ASG SUPERCONDUCTORS

MEETING INFN/CERN JULY, 31ST 2024

PROJECT: D2

VS-06 APERTURE COLLARING FAILURES ROOT CAUSE

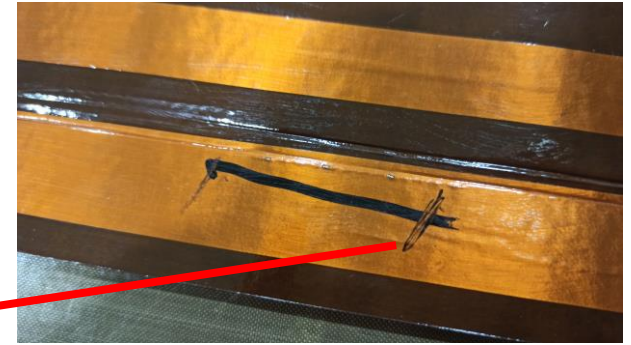
Capacitance measurement carried out in between the Coil BS-08 and the adjcent wedge (2600 mm long) **5 nF** (vs calculation of 5,9 nF).

Circled in red are shown some location of defects detected onto the Quench Heater HCMBRDC006-CR000010 Insulation.

It happened as the adjacent coil protection foil edges damaged it.

About the location (at about 1640 mm from the LC side end) showed that the cross section into where the defect is mainly located is one used for carrying out the measurements of the elastic modulus.

As reference the SHIMMING PLAN #3 (as example), the ground insulation layout modification would consist into:

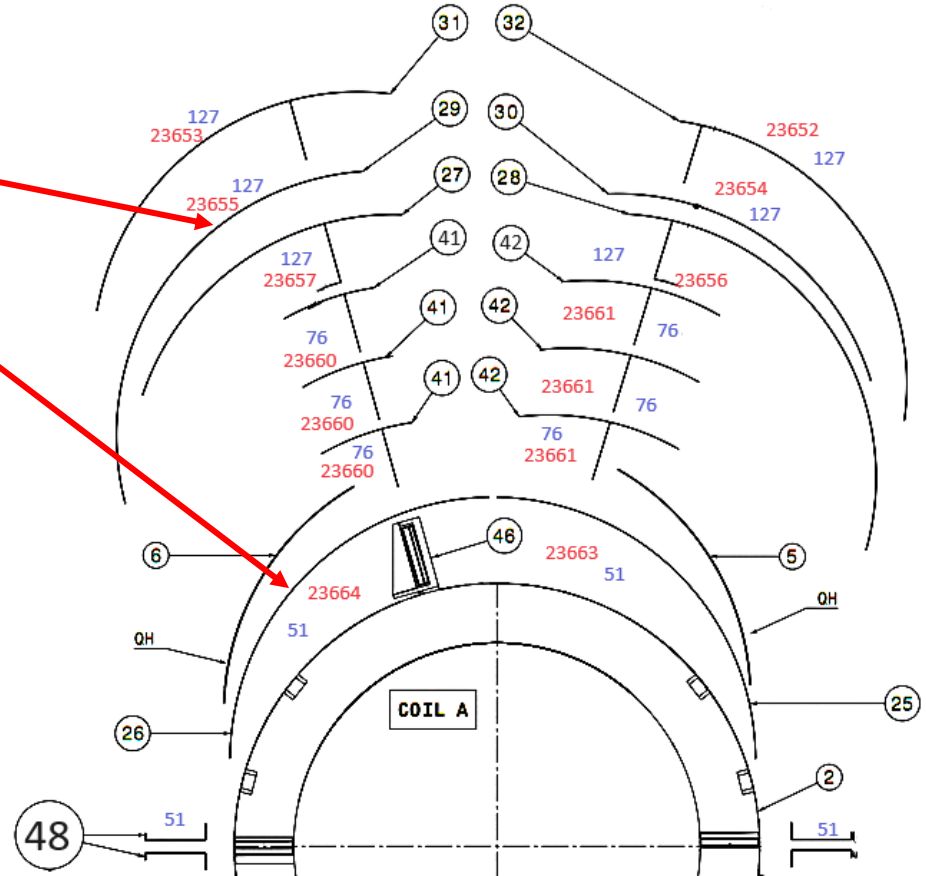
- Substitution of the details Pos.29 and 30 having at present **127 micron** of thickness with thinner ones having the thickness of **50 micron**.
- Substitution of the details Pos. 25 and 26 having at present **51 micron** of thickness with thicker ones having the thickness of **76 micron**.

Having this in mind the overall thickness saving would consist into 51 micron.

The overall reduction of the ground insulation thickness is about 50 micron.
